Docket Numbers 52-014 and 52-015

**BELLEFONTE COMBINED LICENSE APPLICATION – RESPONSE TO
ENVIRONMENTAL REPORT REQUEST FOR ADDITIONAL INFORMATION –
SOCIOECONOMICS/ENVIRONMENTAL JUSTICE**

ENCLOSURE
RESPONSE TO ENVIRONMENTAL REPORT REQUESTS FOR ADDITIONAL INFORMATION
SOCIOECONOMICS/ENVIRONMENTAL JUSTICE

Aerial Image Illustrating the Spatial Relationship between BLN, Creeks Edge Addition, and Residences West of the Mud Creek Embayment

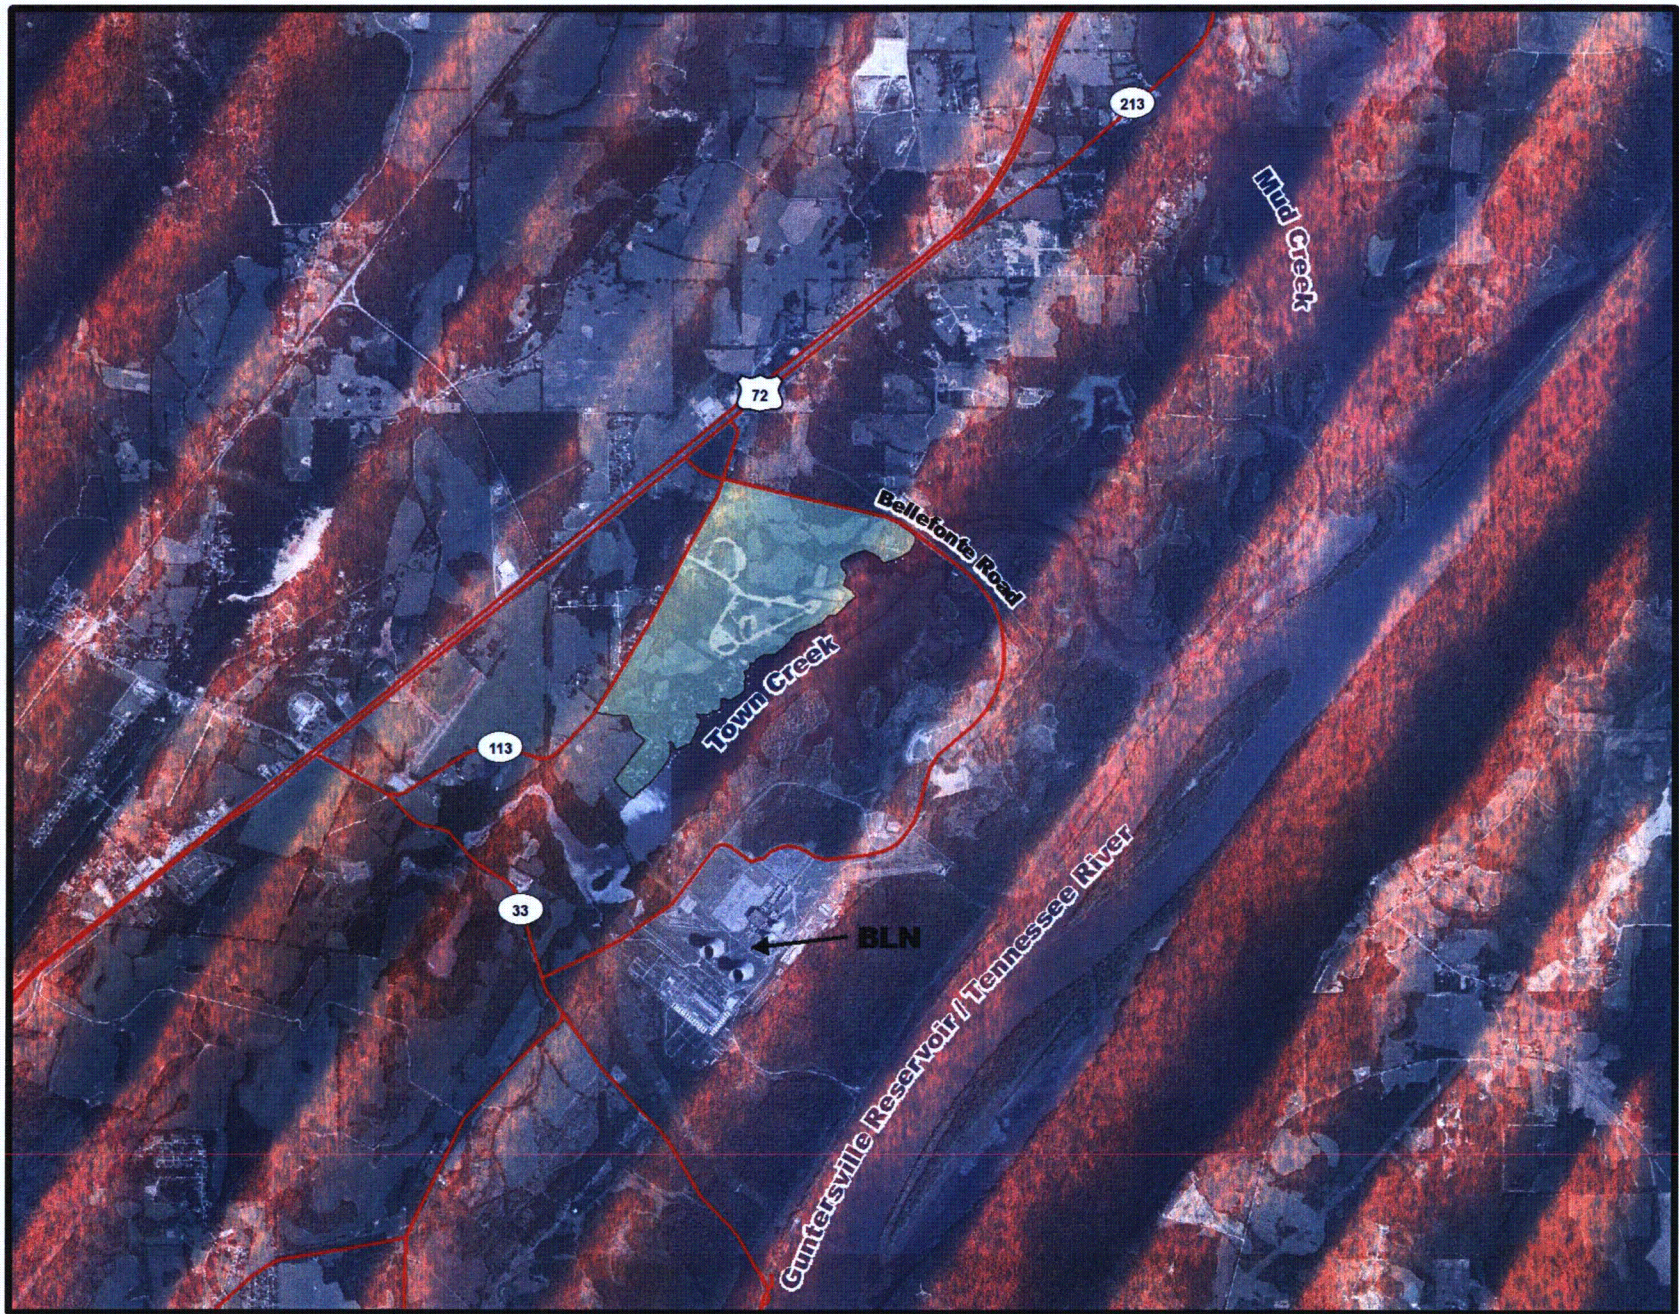
- RAI 2.5.2-1:** Provide information (demographic, housing, transportation) describing the neighborhood(s) across Town Creek from the plant site in ER Section 2.5.1.2 or 2.5.2.6. Include a map/graphic of this area at a scale that illustrates the relationship of residences to the plant and transportation routes.
- RAI 4.4.3-1:** Clarify the basis for excluding the minority population across Town Creek from the site from further consideration for impacts, including those caused by housing demand and traffic as well as noise and air quality impacts. (ER Section 4.4.3)

- 2.5.2-1:** *This request has been satisfied by the TVA letter dated July 03, 2008 with the exception of the map requested and providing clarification that the entire area across Town Creek from the plant is included in the analysis, not just the Creeks Edge development.*
- 4.4.3-1:** *This request has been partially satisfied by the TVA letter dated July 03, 2008 with the exception of making it clear that the analysis has included all of the residents across Town Creek from the plant – not just the residents of Creeks Edge.*

The figure provided as Attachment 2.5.2-1 to this enclosure is an aerial image with transportation routes overlaid that illustrates the geographic relationship between BLN, the Creeks Edge development, and the residential area located west of the Mud Creek embayment and south of U.S. 72 and along the BLN access roads. The residential area located on the west side of Mud Creek and south of County Road 213 is not a named housing addition. The location and characteristics of the Creeks Edge development and Mud Creek area housing are discussed in further detail in the BLN responses to NRC Information Needs SE-07 and SE-18. The minority block groups near the BLN site are discussed in the BLN response to NRC Information Need SE-28. Impacts to minorities, including those near the BLN site, are discussed in the document provided as Attachment B in the TVA letter dated May 2, 2008 (Reference 3).

Residents directly across the water, including those in the Creeks Edge development and in the area west of the Mud Creek embayment were included in the impact analyses.
